Work Order ID 78925

Item Name: Mounting Lug

DRAWING NO. D2731	TITLE MOUNTING LUG	REV. C	DART AEROSPACE USA, INC ENGINEERING ORDER		D.E.O. NO. D2731-C-1	SHEET NO. SHEET 1 OF 1	SCALE NTS
DRAWN GP	CHECKED SC	MFG. APPR. M	APPROVED MD		DE APPR. H		
DATE 11.05.02	DATE 11.05.09	DATE 11.05.09	DATE 11.05.09		DATE 11.05.09

ADD D2731-xRG OPTION

D2731-1RG MOUNTING LUG (SHOWN)
D2731-3RG/-5RG/-7RG MOUNTING LUGS (SIMILAR)

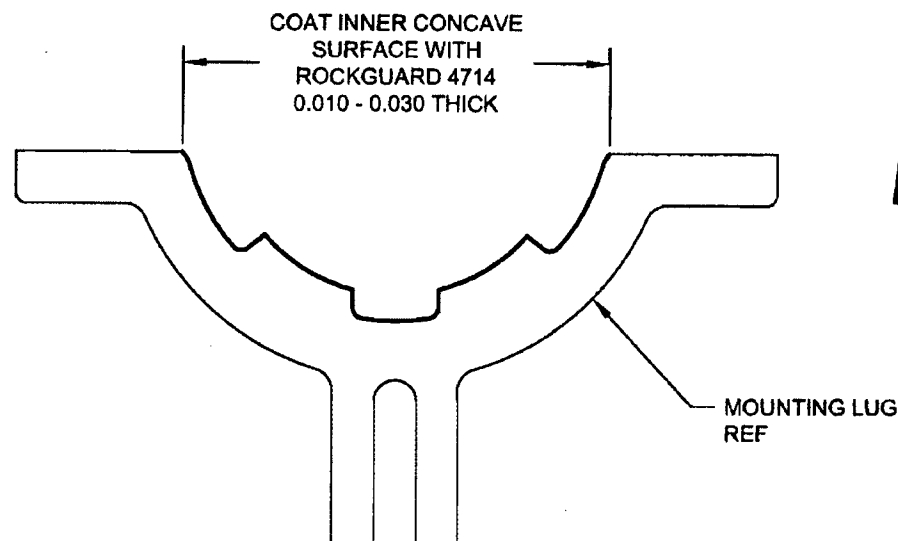
D2731-xRG MOUNTING LUGS ARE INDENTICAL TO D2731-x MOUNTING LUGS, HOWEVER AFTER FINISH, COAT INNER CONCAVE SURFACE WITH "PLUS ONE ROCKGUARD 4714" AS SHOWN BELOW.
